**DOS RIOS WRC CHLORINE SYSTEM IMPROVEMENTS**  
**Solicitation Number: CO-00197**  
**Job No.: 17-6508**

**ADDENDUM 3**  
**September 19, 2018**

BAR IS ONE INCH ON ORIGINAL DRAWING  
 IF NOT ONE INCH ON THIS SHEET, ADJUST SCALES ACCORDINGLY.  
 DRAWING NUMBER **20-M302**  
 SHEET NUMBER **114**

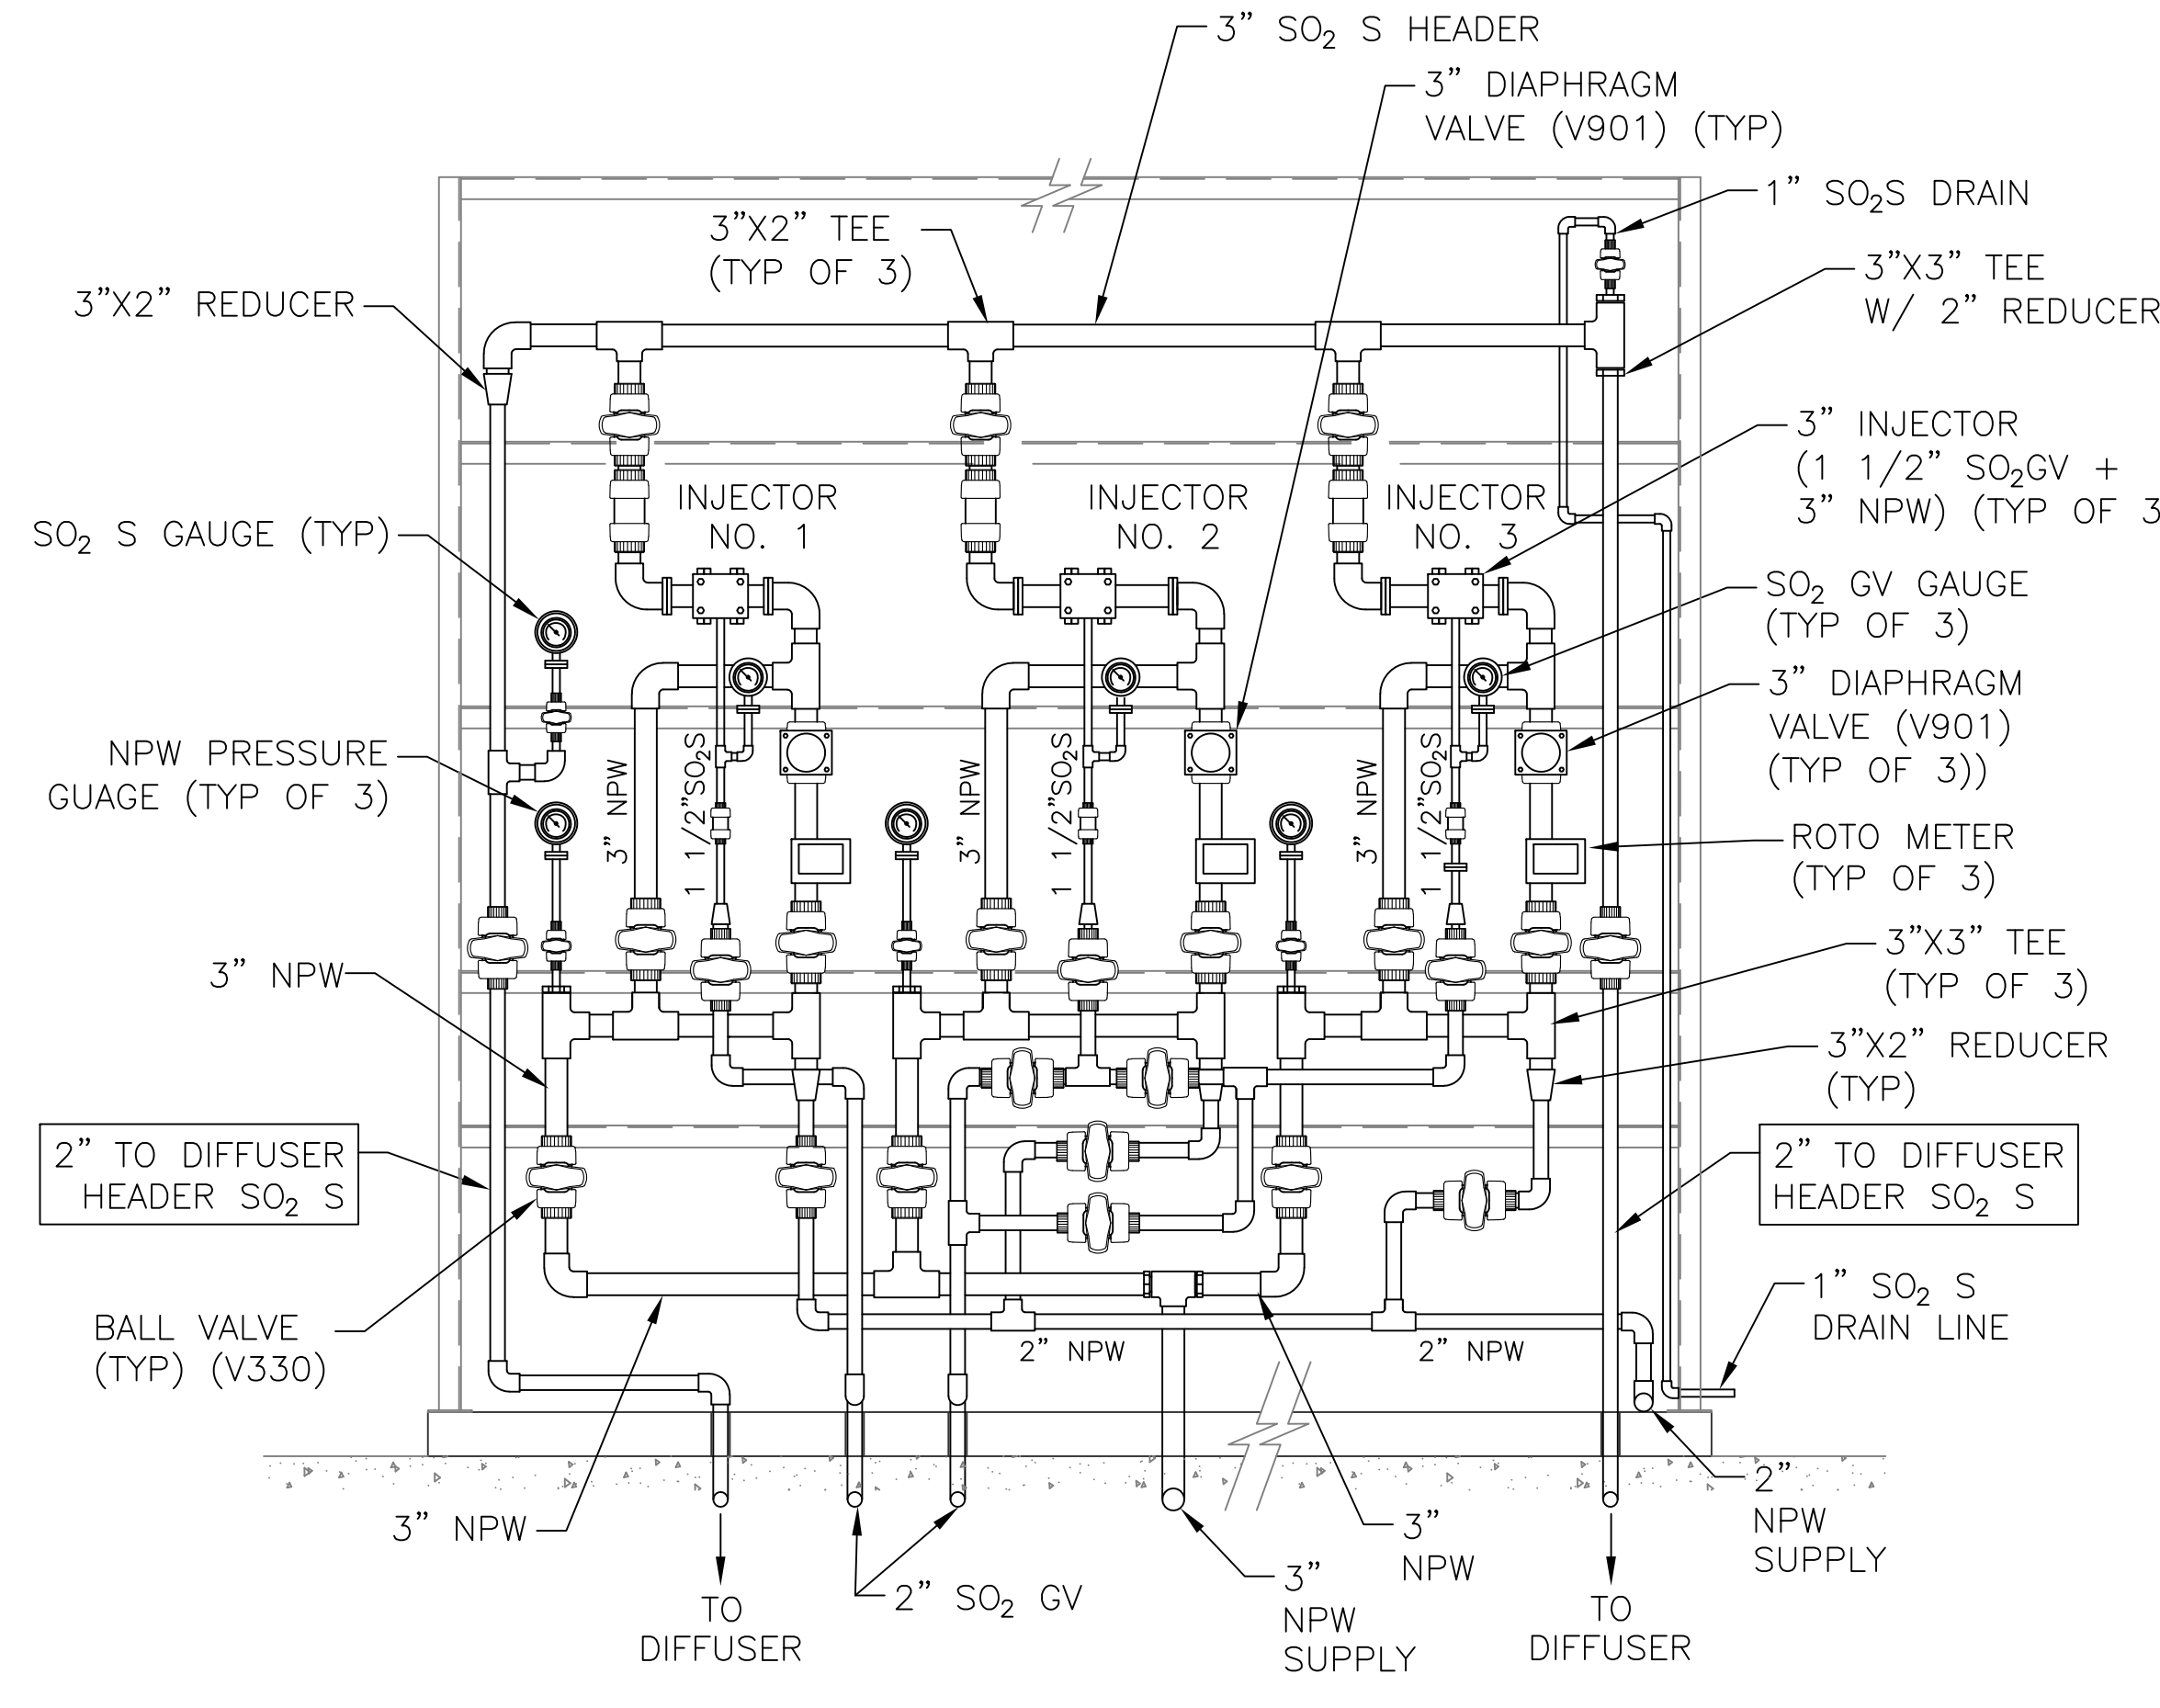
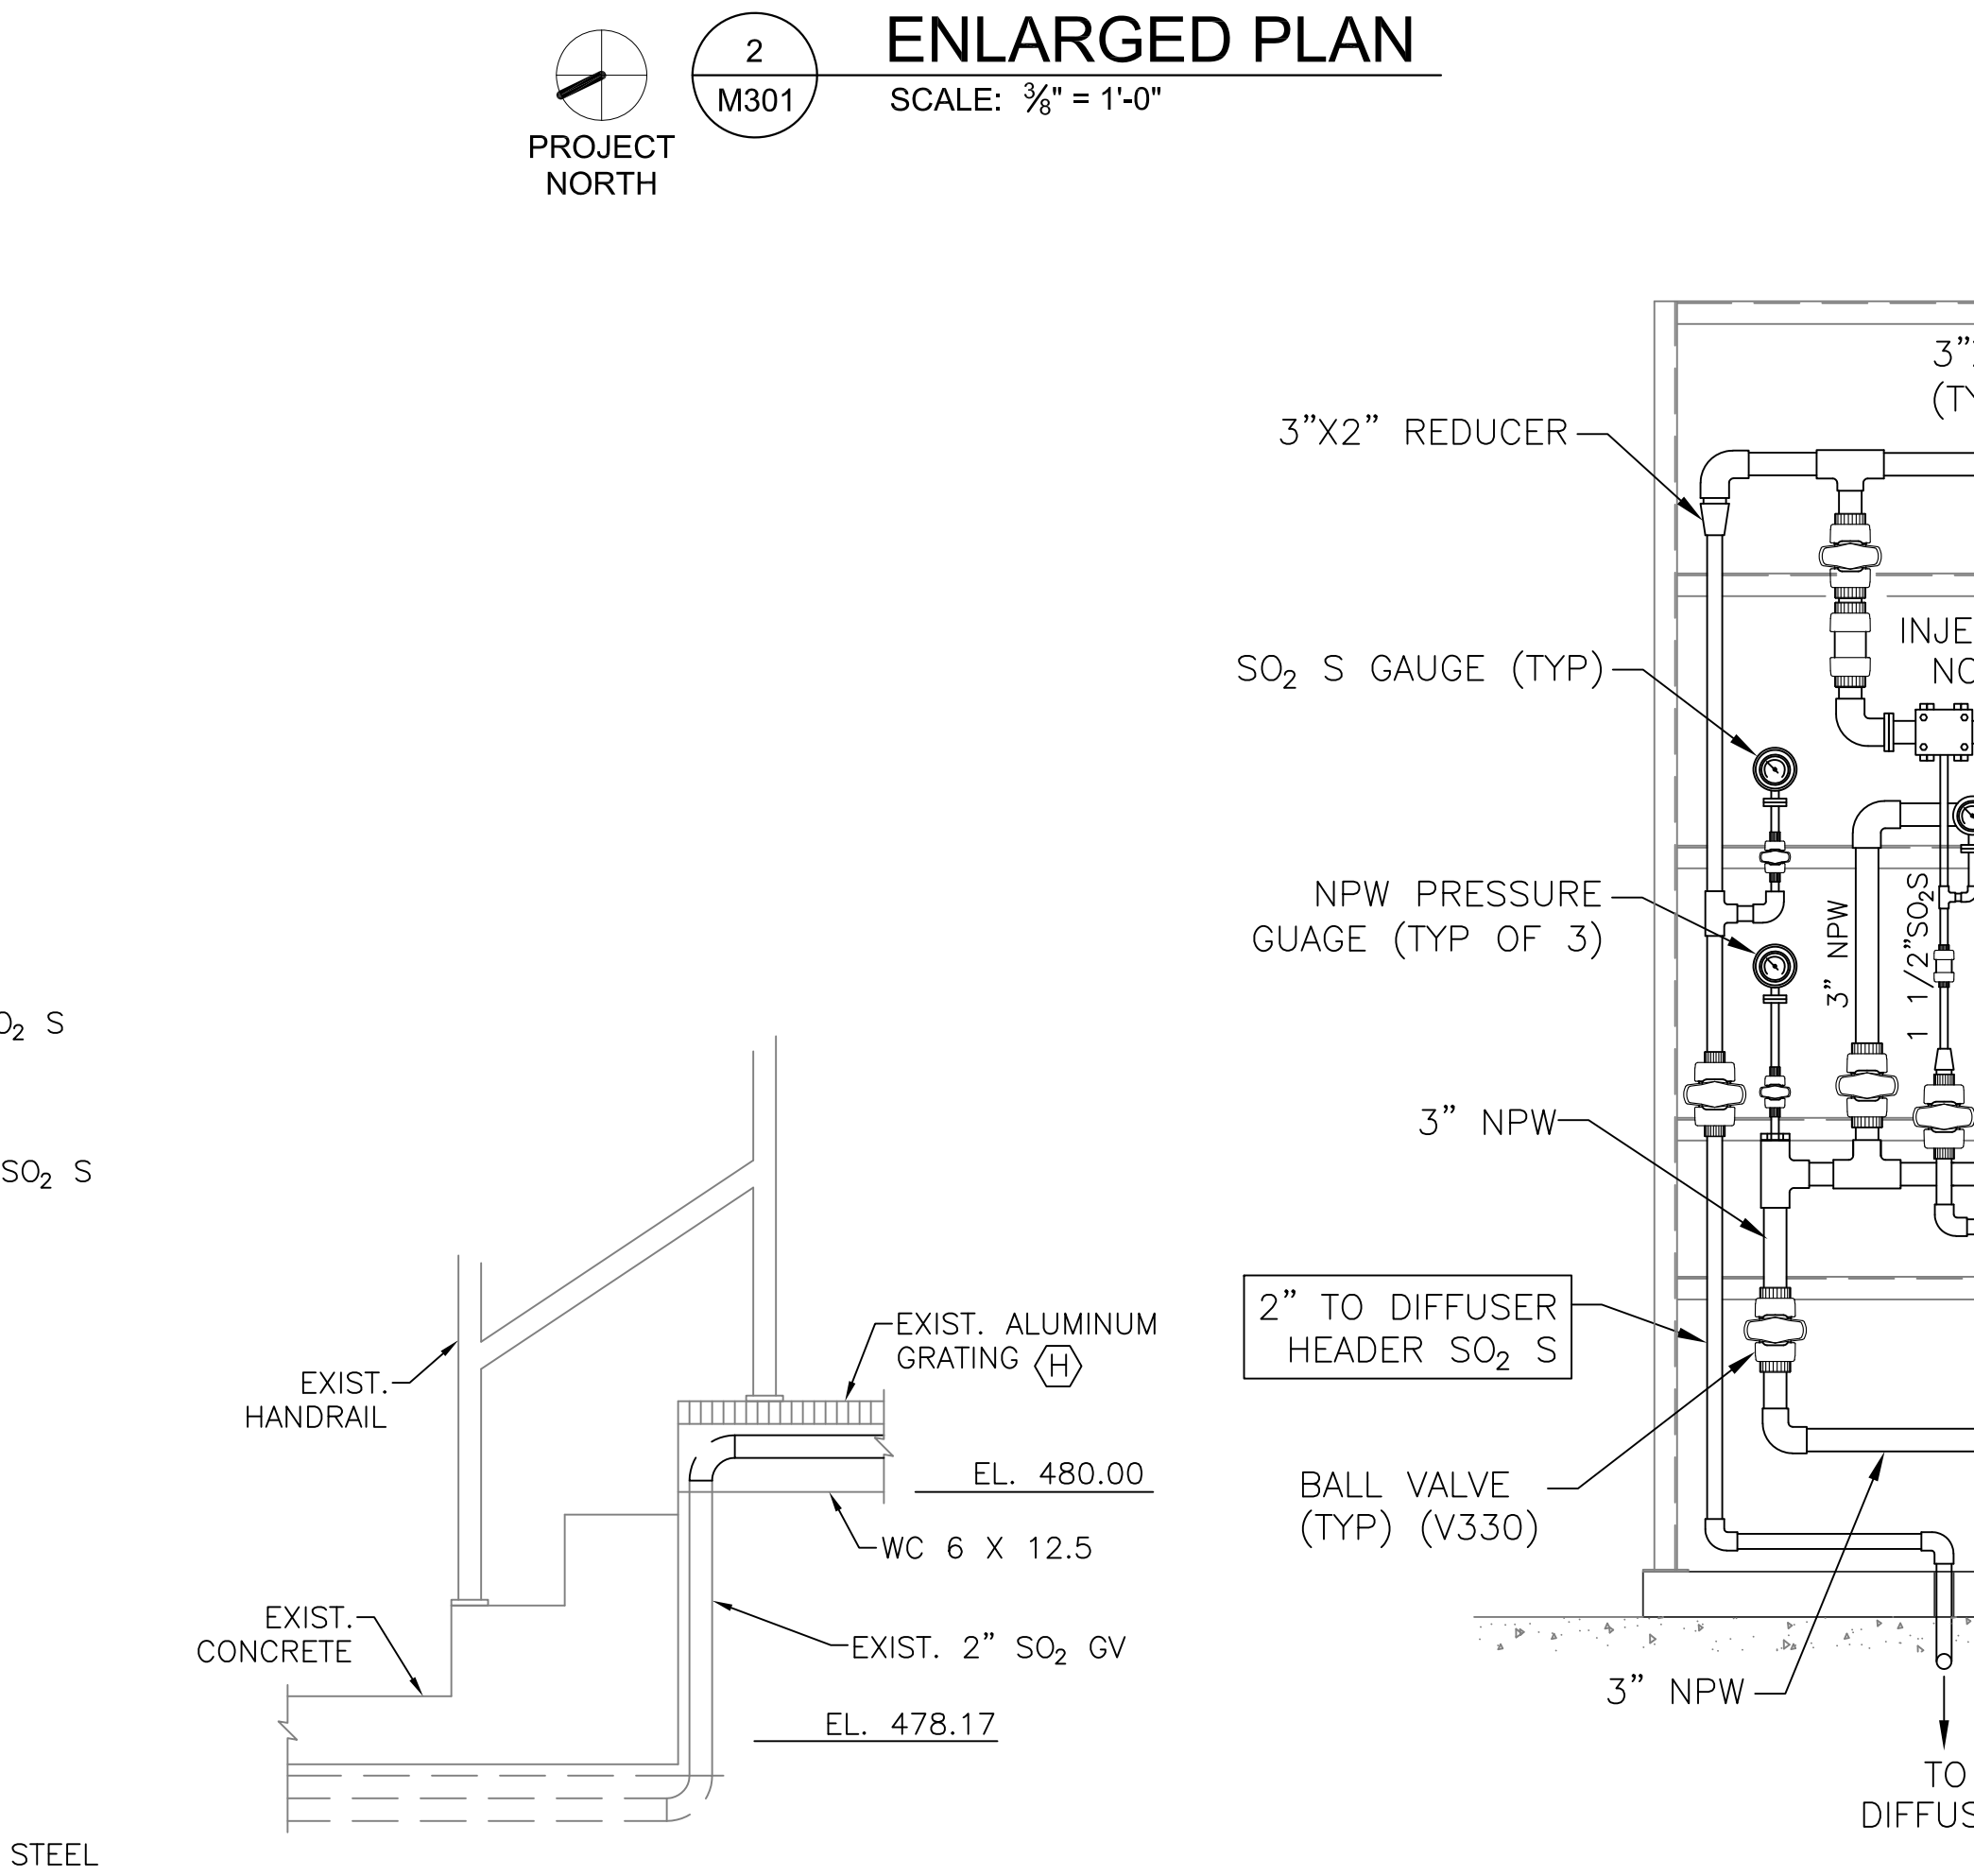
22. DWG 20-M302, Section E: Please clarify the following items:

- 45. Sheet 20-M302
  - a. Replace the sheet with the attached. Section E was modified to clarify pipe sizes at the injector panel.
- 46. Sheet 20-E133
  - a. Change reference on Detail B from "20-E134" to "20-E133"
- 47. Sheet 20-E134
  - a. Corrected scale reference bar to match the scale reference shown on the rest of the drawing.
- 48. Sheet 20-E402
  - a. Correct reference in note-by-symbol 1 text from "20-E136" to "20-E134"

Response: Refer to revised DWG 20-M302. Section view was modified to clarify line sizes, etc.
